Information note

N° 089/21

Additional source for solder pins of Easy modules

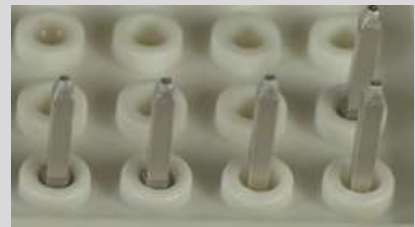
Subject Release of additional supplier for solder pin

Reason Secure delivery capabilities

<u>Old</u>	<u>New</u>
<ul style="list-style-type: none"> Existing solder pin supplier 	<ul style="list-style-type: none"> One new solder pin supplier

Existing solder pin supplier

One new solder pin supplier

- ▶ **Impact of change** Optical difference between both sources with no impact on electrical performance.
Quality and reliability verified by qualification.
Dual sourcing for solder pin for Easy products.
